7.1.3 ACTIVITY CENTRE PROGRAM - OAKLEIGH, HUGHESDALE AND HOLMESGLEN

Responsible Manager:	Sean McNamee, Manager Strategic Planning
Responsible Director:	Peter Panagakos, Director City Development

Image 1.

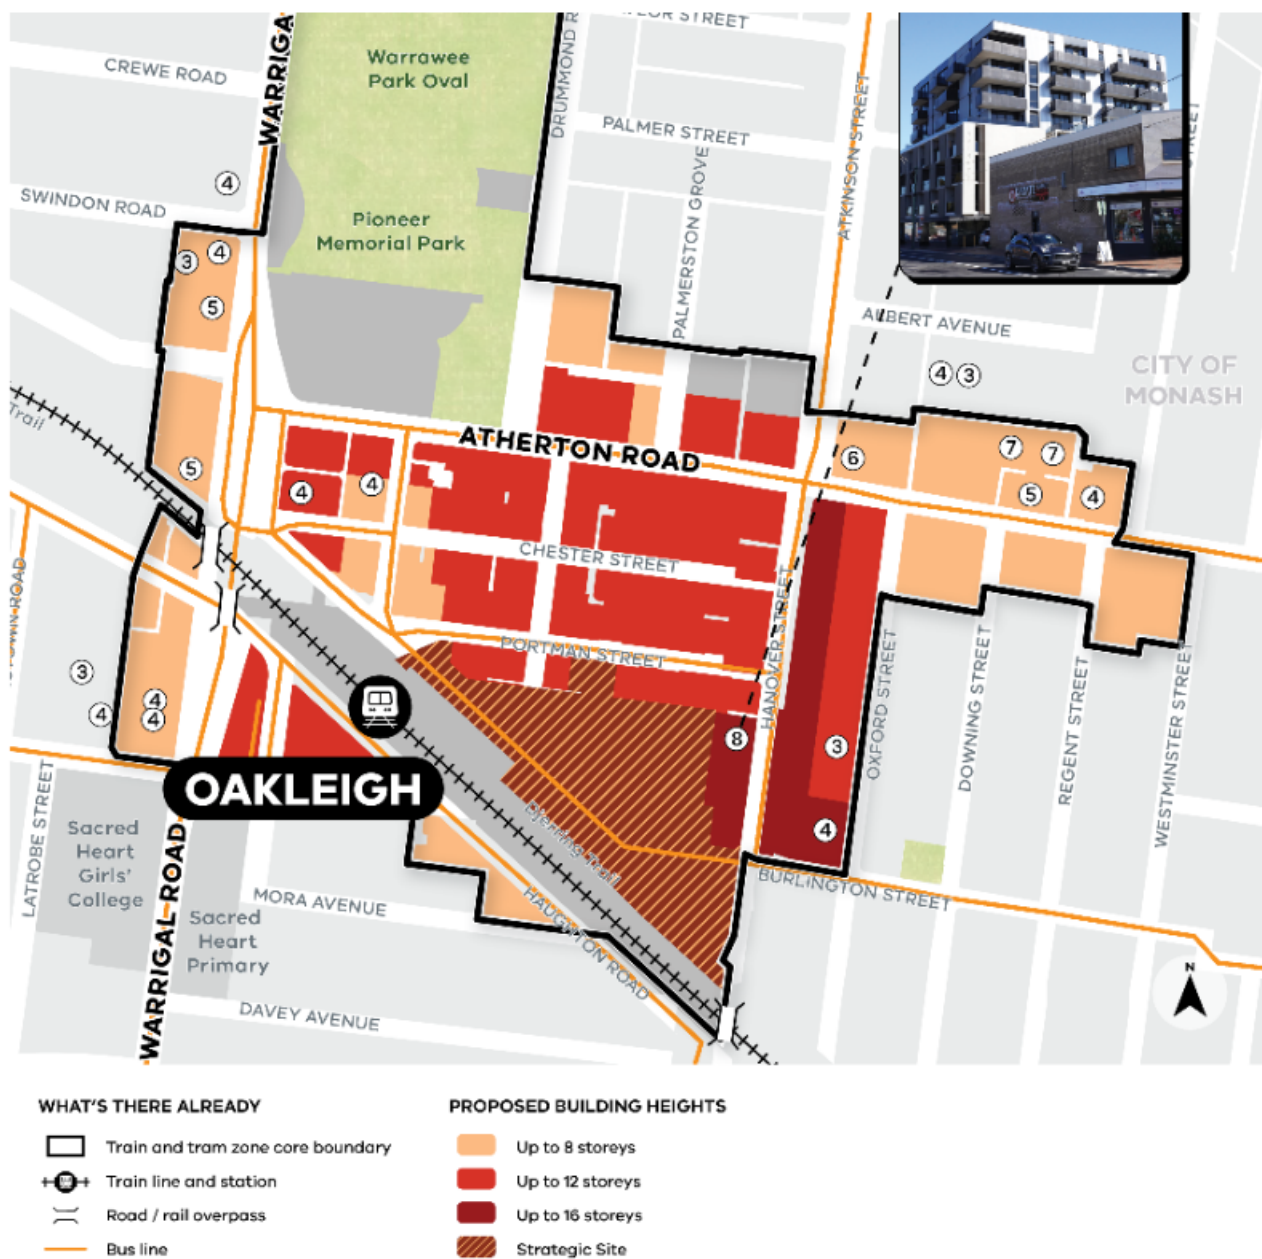
A high degree of change is proposed in Oakleigh.

The draft plans propose building heights of:

- 16 storeys along Hanover Street,
- 12 storeys in the Eaton Mall central core (Portman Street, Chester Street and Atherton Road), and
- 8 storeys through some heritage areas, including the Station Street heritage precinct as shown in **Image 1**.

Figure 1: Assessment distance for ~~Calculation of~~ wind effects

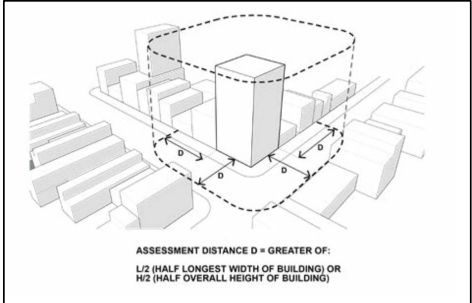
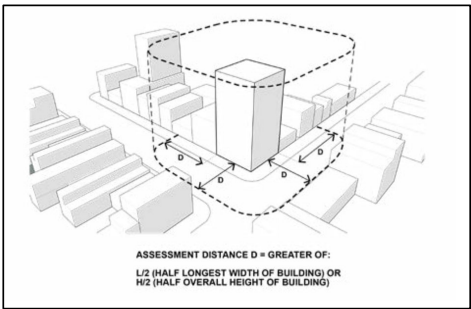
- should achieve comfortable wind conditions (as specified in Table 1) in public land and publicly accessible areas on private land within the assessment a distance ~~half the greatest length of the building, or half the total height of the building measured outwards on the horizontal plane from the ground floor building facade, whichever is greater~~ as shown in Figure 1.

Figure 3 Proposed change to catchment boundary

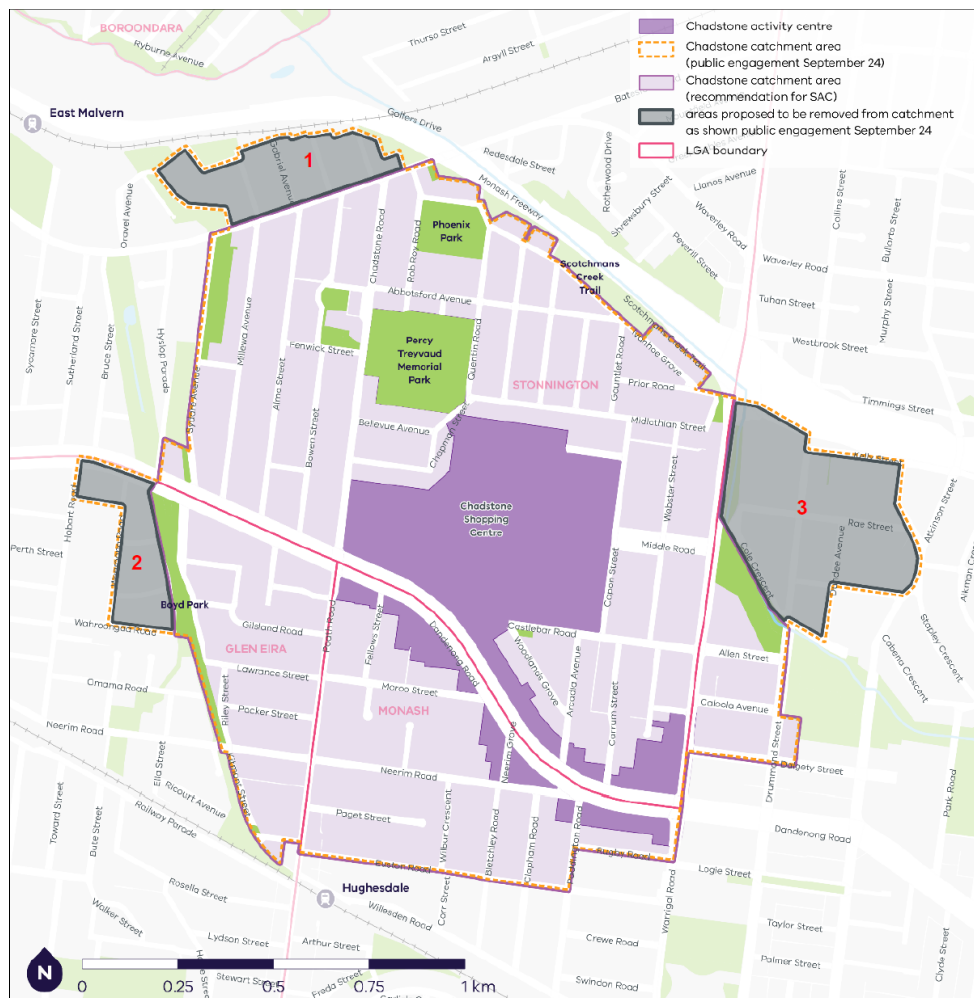
The VPA proposes to change the catchment boundary to exclude the grey shaded areas in Figure 2 for the following reasons:

- Area 1 – distance to core commercial amenities and services of the Activity Centre
- Area 2 – distance to core commercial amenities and services, and the physical barrier of Boyd Park
- Area 3 – the barriers presented by Scotchman's Creek and the Monash Freeway.

Monash also submitted the catchment area should not be included in the Activity Centre Plan, suggesting a distance of 800 metres from the edge of the shopping centre is excessive. It specifically recommended removal of Area 3 on Figure 3, as it includes heritage areas and is separated from the Activity Centre by a significant physical barrier (Warrigal Road).

Glen Eira submitted the area west of Boyd Park (Area 2 on Figure 3) should be removed.

- exclude Areas 1, 2 and 3 identified in Figure 3 as they are too distant from the services within the Activity Centre that serve day to day needs (and are separated by physical barriers)
- exclude areas south of Dandenong Road and east of Warrigal Road, as these major roads present significant physical barriers to pedestrian access to the shopping centre
- measure the 800 metres walkable distance from the commercial services within the centre that serve day to day needs (not the outer edges of the carparks)
- exclude all Fringe Precinct areas and the Percy Treyvaud Memorial Park from the area from which the 800 metres is measured.

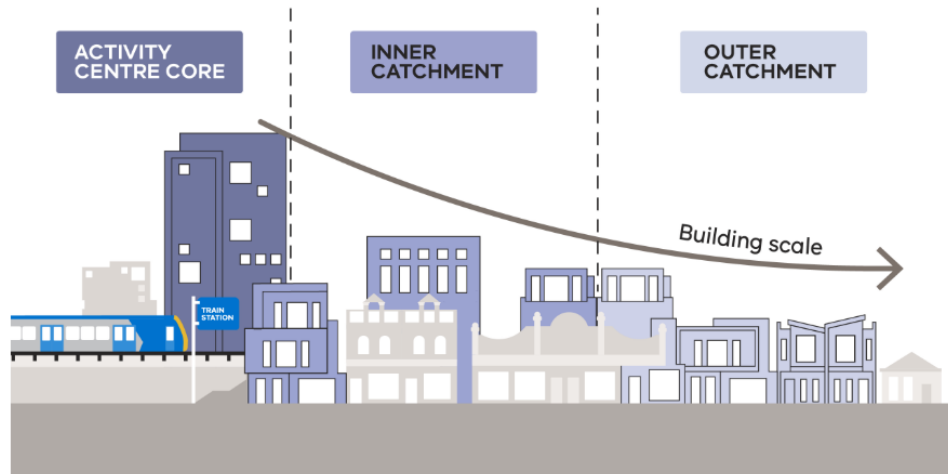
The 12 storey height limit applies to most of the land in the main centre of Oakleigh, including Atherton Road, Chester Street, and Portman Street. Of particular concern is the 12 storey height limit applying to the Eaton Mall precinct.

While Council supports more housing in Oakleigh, we strongly object to the heights proposed in the core, particularly to the eight and 12 storey limits in Atherton Road, Chester Street, and Portman Street between Station Street and Hanover Street, and on both sides of Station Street.

The current Oakleigh Structure Plan has a discretionary height limit in this area of four storeys (with site specific exceptions), and this should remain the height limit, with applications above this height to be tested on a site by site basis. The fragmentation of ownership in this area means that development even at these heights is likely to be challenging.

Council objects to the proposed 12 storey height limit in the central core of Oakleigh and submits that the current height limits envisaged in the Oakleigh Structure Plan should remain for this area, with any taller buildings able to be assessed on a case by case basis at application time under the objectives of the Oakleigh Structure Plan.
